**Reference:** Case No. PD-270-RBN, The Avenue at Denton Tap, a zoning change request from Commercial to a Planned Development to allow 29 multifamily units and 8,575 square feet of office/retail uses on 1.77 acres of property located at the northwest corner of Southwestern Boulevard and South Denton Tap Road.

**STAFF REPORT**

**CASE NO. PD-270-RBN, The Avenue at Denton Tap**

Site Plan

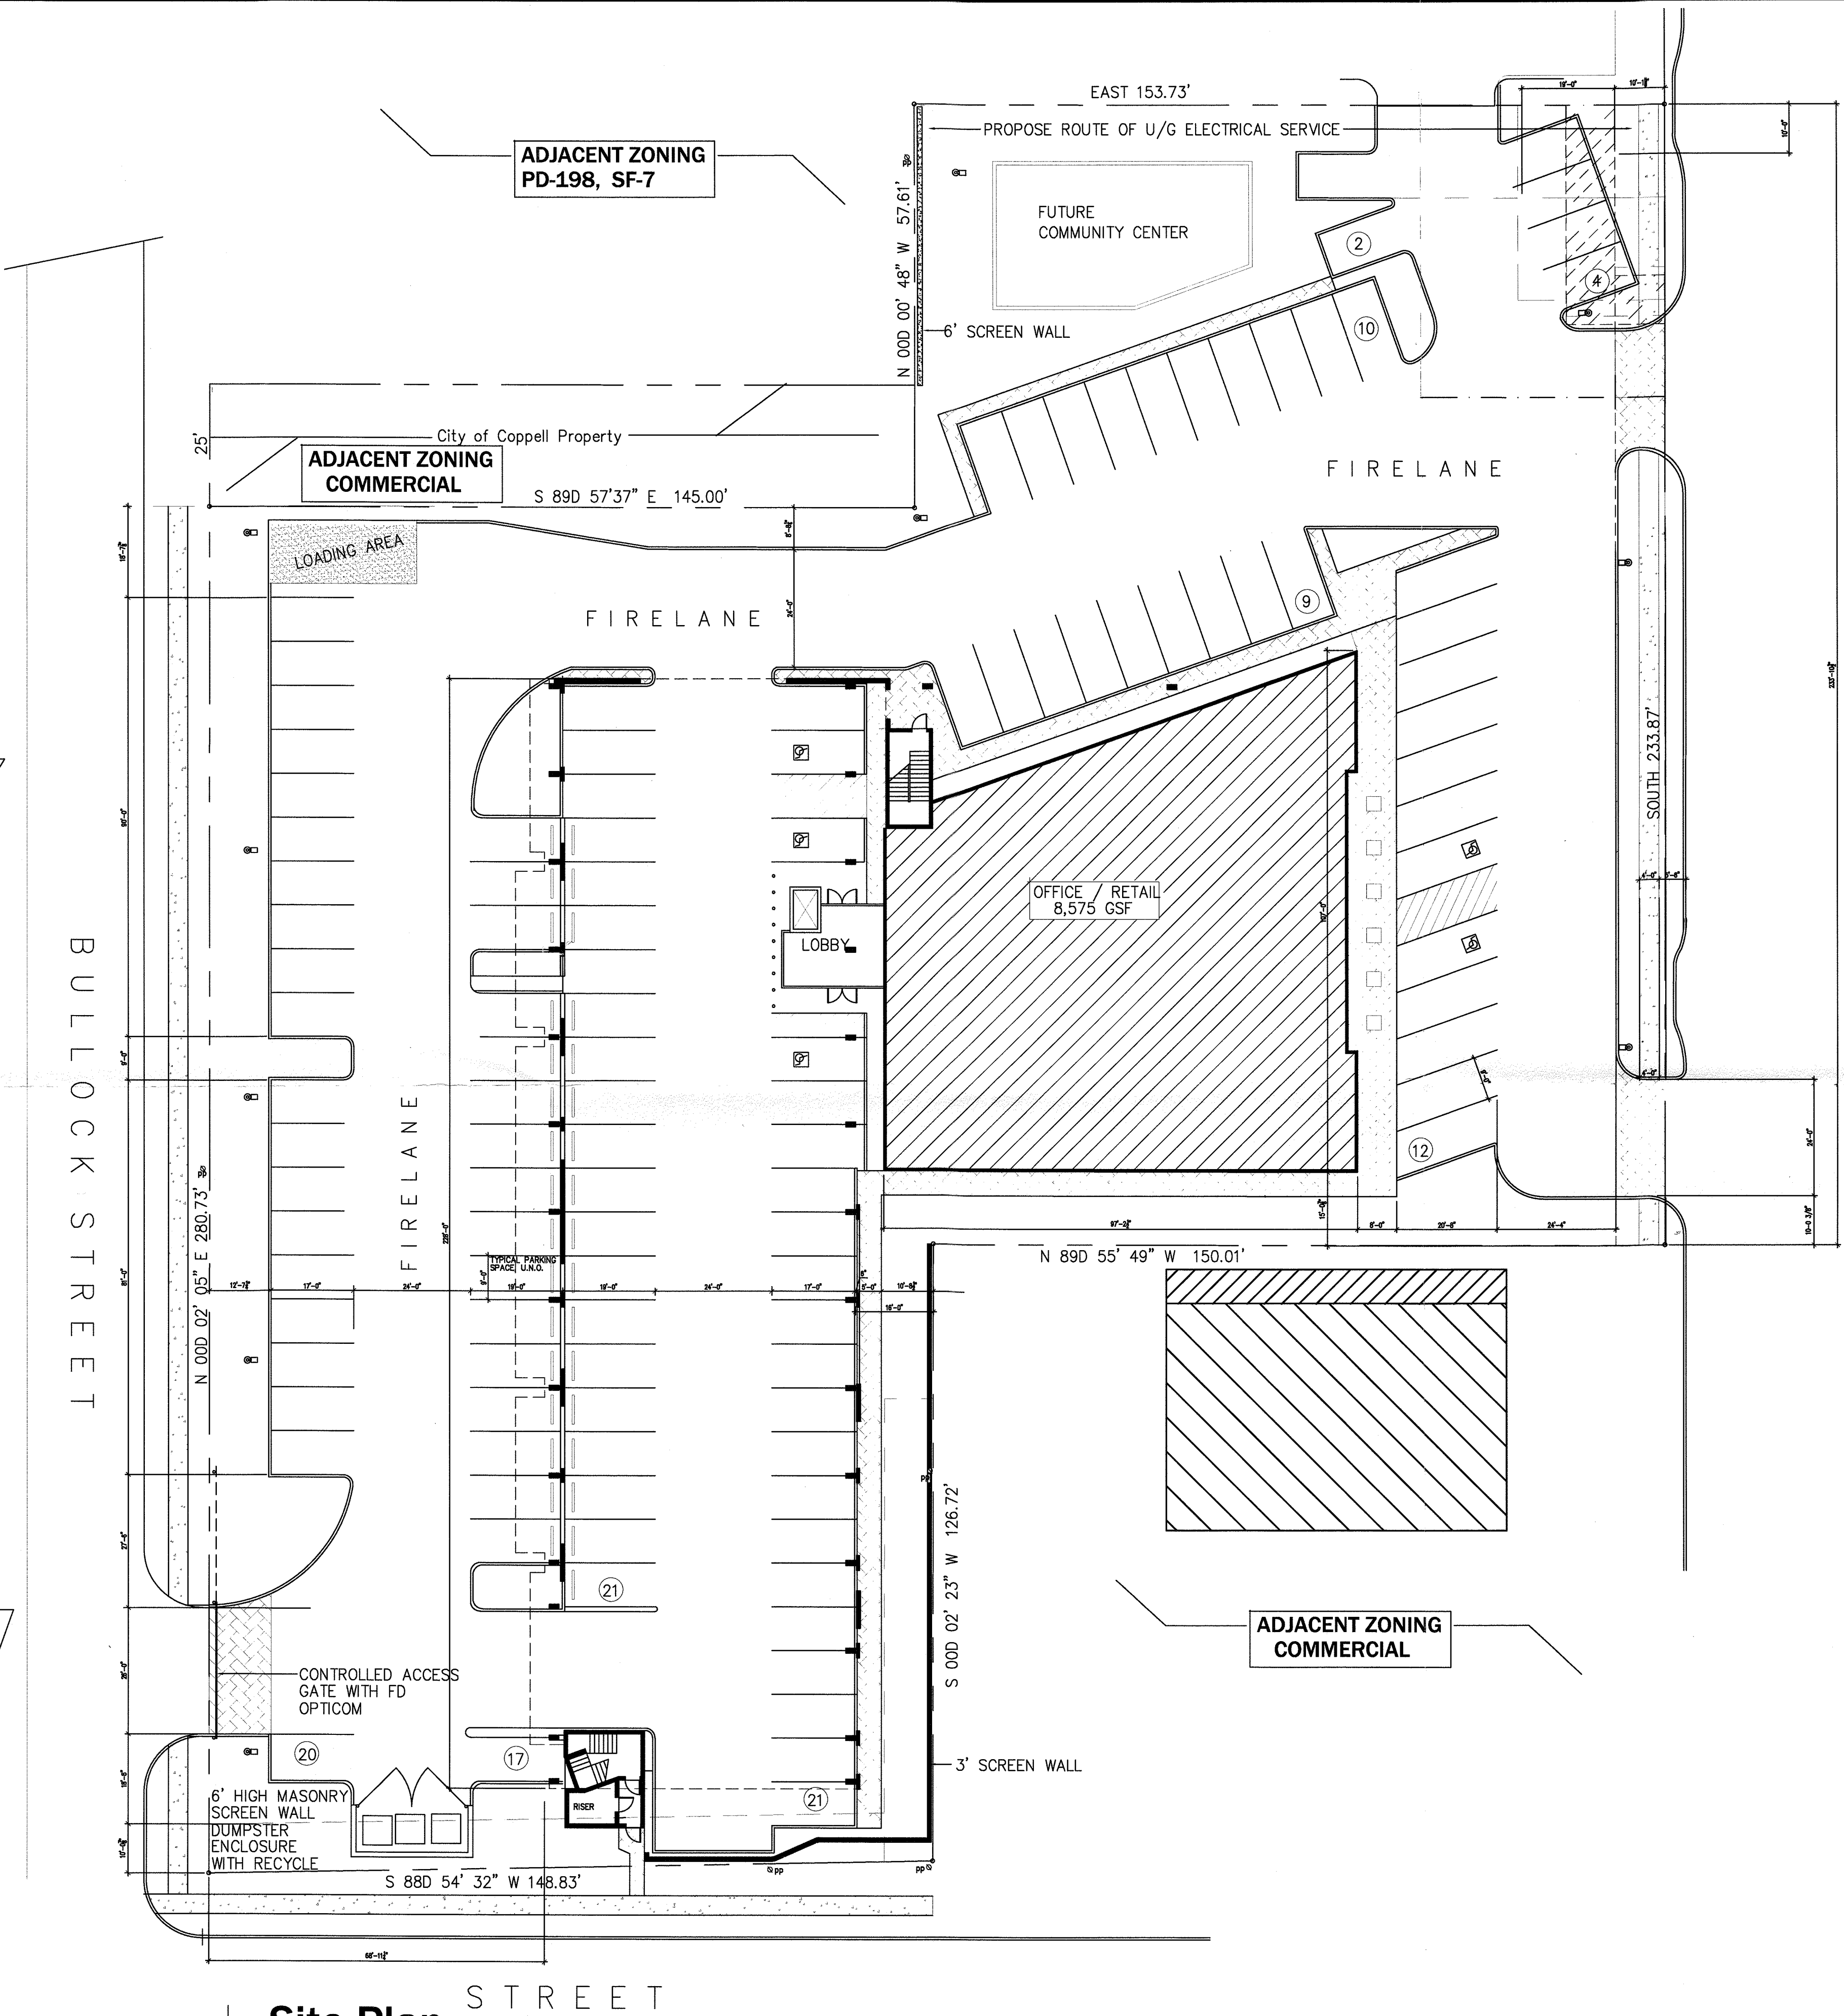
This building is proposed to be setback 63 feet from Denton Tap Road and 69 feet from Bullock Street. It is recommended that the 69-foot setback be supported to keep a buffer and transition from the residential neighborhood into the proposed higher intensity mixed use development.

A 36-foot setback is proposed along the northwest property line, which is adjacent to a 25-foot right-of-way providing a greater separation from the residential neighborhood. The main building is 63 feet from the Denton Tap Road right-of-way where the RBN District calls for a building to be no more than 15 feet from the lot line. Staff can support this deviation, as both a drive and parking are warranted for the office/retail use.

This proposal exceeds the 116 parking space requirement by providing 119 spaces. Both the *Comprehensive Plan* and the RBN District encourages structured (garage) parking. In this development 41 of the 119 spaces are contained within the structure. It is recommended that this parking area on the first floor be better screened with a three-foot masonry wall incorporated into each façade and this has

been listed as a condition of approval. Beyond the structured parking are 41 spaces in a parking lot. This area is proposed to be screened with a 12 foot wide landscaped area east of Bullock Street. The proposed off-street parking and drive (similar to a slip street recognized in the Comprehensive Plan). The proposed parking located on the Denton Tap Road side is angled with a one-way drive to provide an opportunity for streetscaping without actually having dangerous on-street parking on Denton Tap.

| 5.  | A three-foot masonry wall shall be incorporated in the façades of the main building to better screen parking area contained within the building.   |
| 8.  | Include three 150-square-foot landscape islands with an overstory tree within the proposed surface parking area where not under the structure. No more than 15 spaces are typically permitted without an island and one island is required at the end of each parking row. |
| 12. | Label the 25-foot right-of-way northwest of the site as City of Coppell Property. Include Eastern Red Cedars and Nellie R. Stevens south of the existing fence.  |
| 14. | List all requested variances to the RBN District in the PD Conditions table.   |
| 16. | Include a gate with controlled access (include opticom for Fire Department) at the southwest access point off of Bullock.  |
| 17. | Relocate the dumpster enclosure to the south end of the project.   |

1 LANDSCAPE PLAN  
SCALE 1"=20'

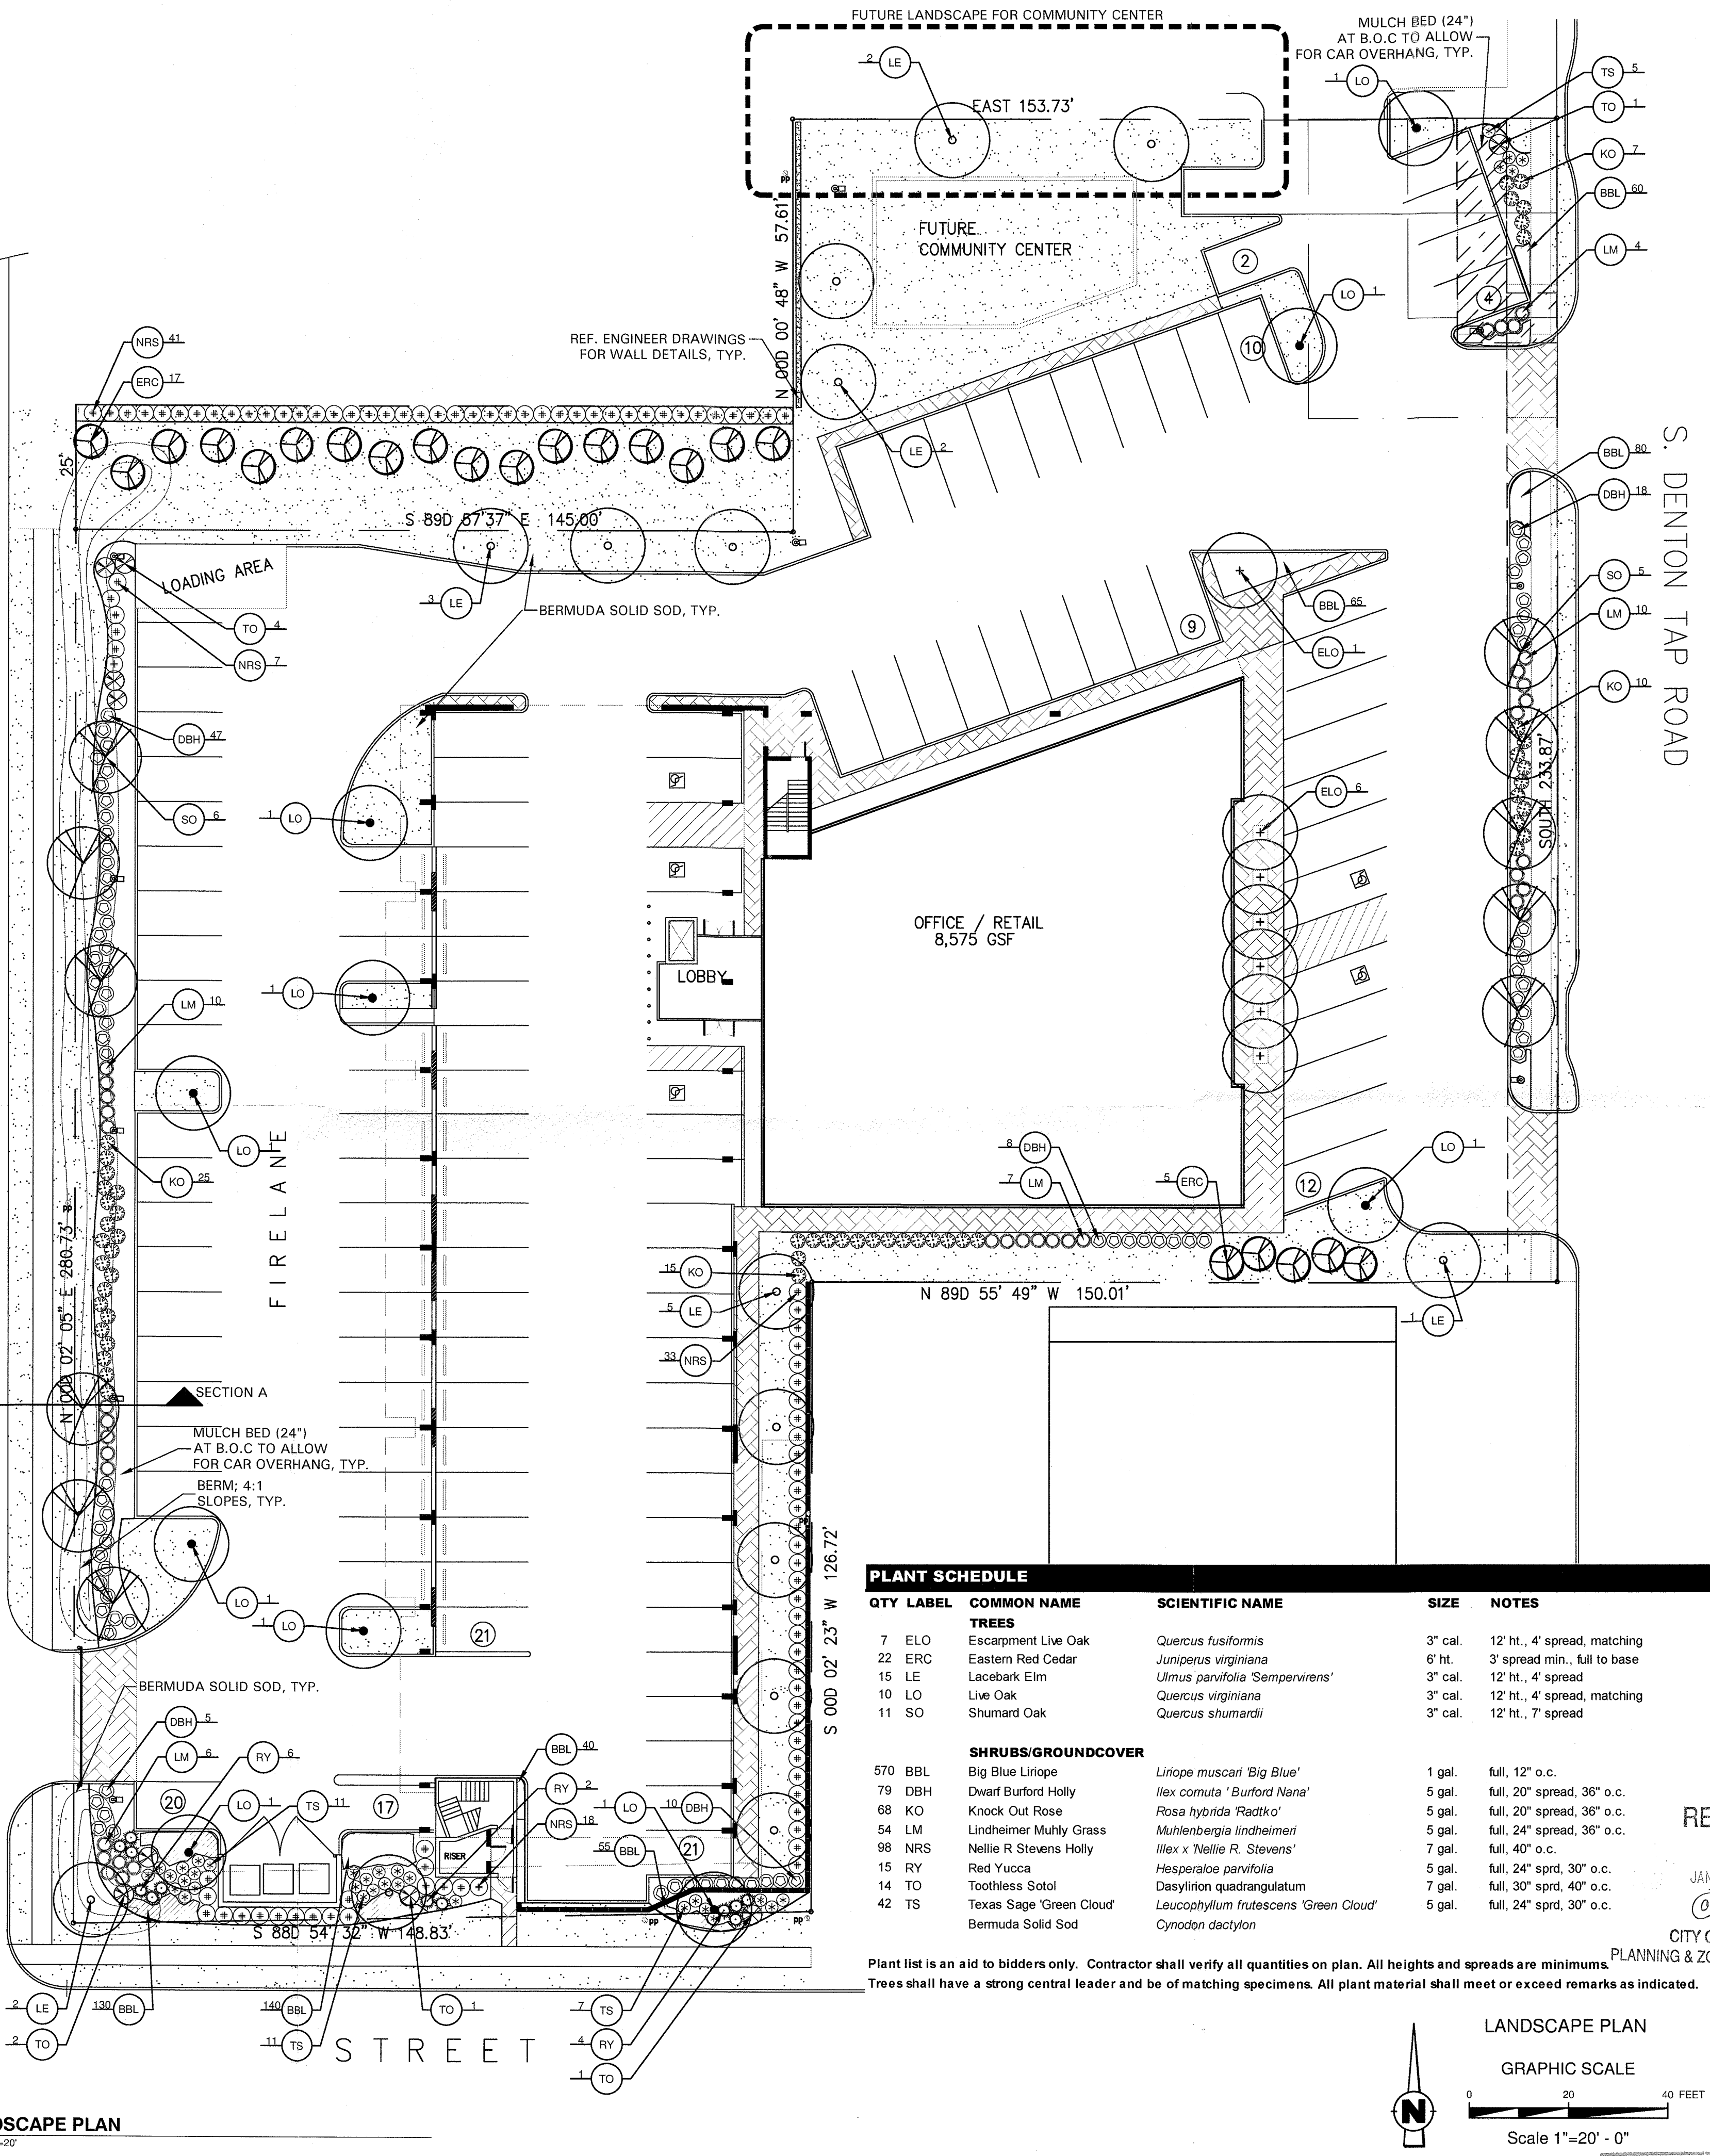
The landscape areas within a RBN District are different than the typical business zoning districts where under the RBN, a minimum 15% open space/common area is required. The proposal indicates that 17% has been provided. The streetscaping of the retail/office area is adequate where street trees are being provided. However, additional landscape islands are being recommended in the parking lot where there is no structure over the parking. Not more than 15 parking spaces are typically permitted without an island and one island is required at the end of each parking row; therefore, three islands are recommended. Also, the applicant has agreed to add an evergreen area of landscaping (containing Nellie R. Stevens and Eastern Red Cedars) to the 25 foot right-of-way strip located northwest of the property to better buffer/screen this proposal from the existing residential neighborhood.

| 15. | Revise the Landscape Plan to include interim and future landscaping for the "Future Community Center" portion of the site.   |
